Agenda Item # 4

BOA-003876-2026

2460 Third Avenue

APPLICATION NUMBER	6786	DATE	October 1, 2026
APPLICANT	The Comforter Heating & Air Conditioning		
REQUEST	Use Variance

SITE PLAN

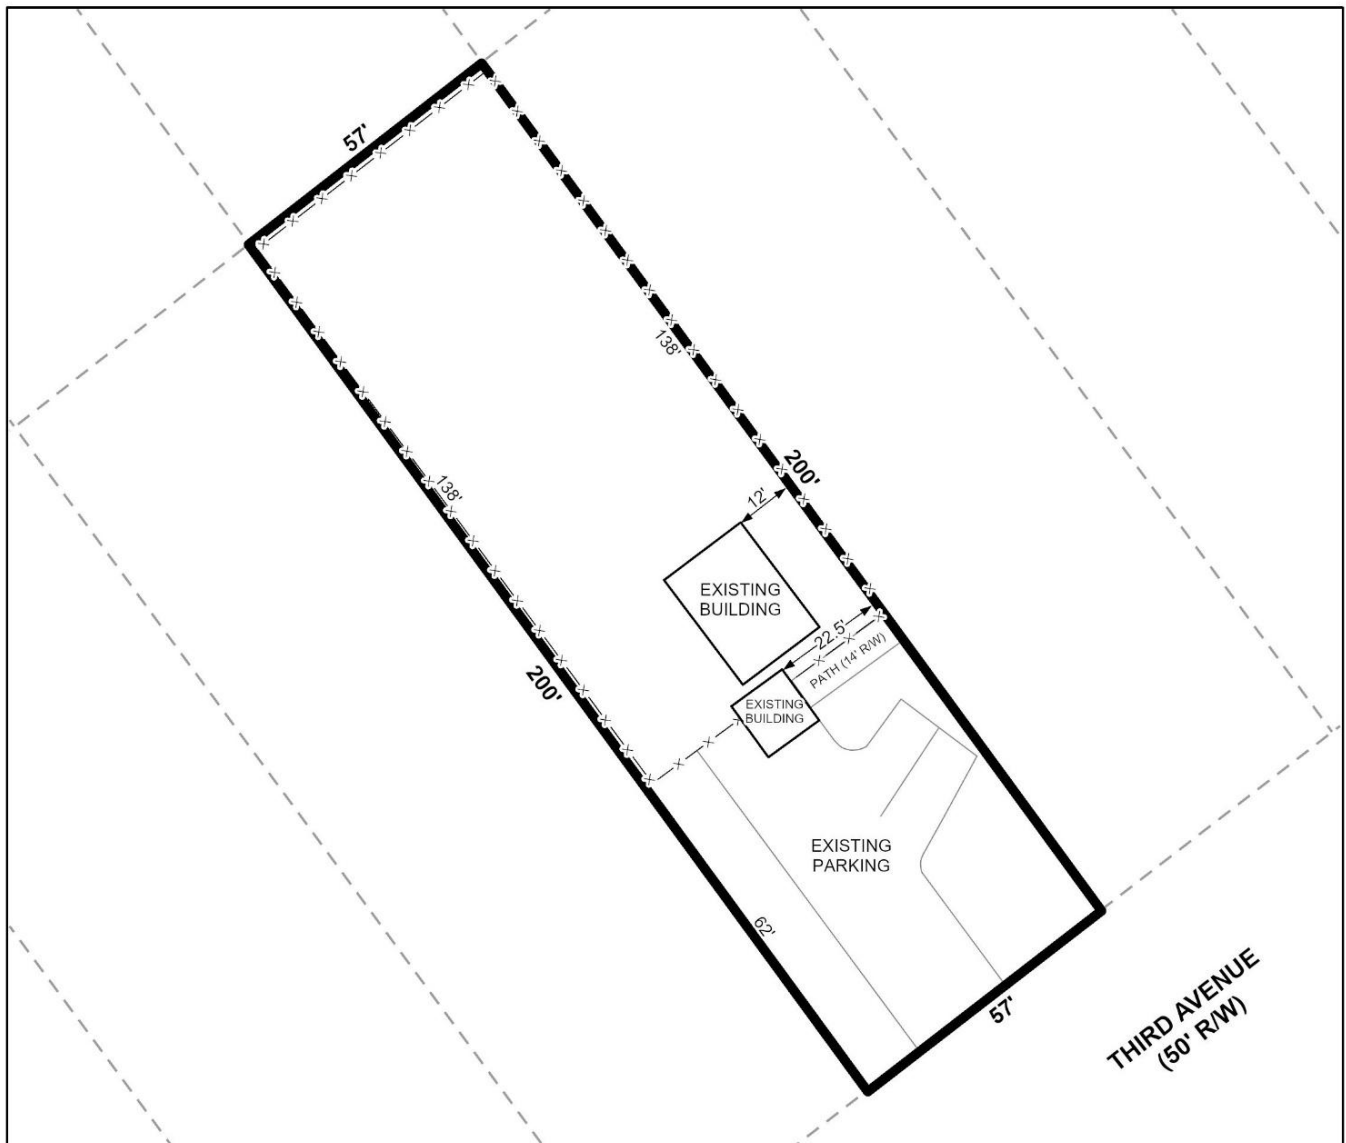
The site plan submitted indicates that the driveway is still proposed to be twelve feet (12') wide, not allowing for two-way traffic. Two (2) parking spaces are provided, although not of compliant size and lacking adequate maneuvering area. No public sidewalk is provided in the right-of-way, and no application to the Planning Commission for a Sidewalk Waiver has been submitted. No tree plantings are proposed, and no compliant residential buffer is provided. It should be noted that several signs have been added to the site without any permits.

As proposed, the site plan does not comply with some conditions of the Court order, specifically screening around the storage area; obtaining of sign permits; and the granting of a Sidewalk Waiver if no public sidewalk is provided. As proposed, the use and site improvements would not be in keeping with the residential character of the neighborhood.
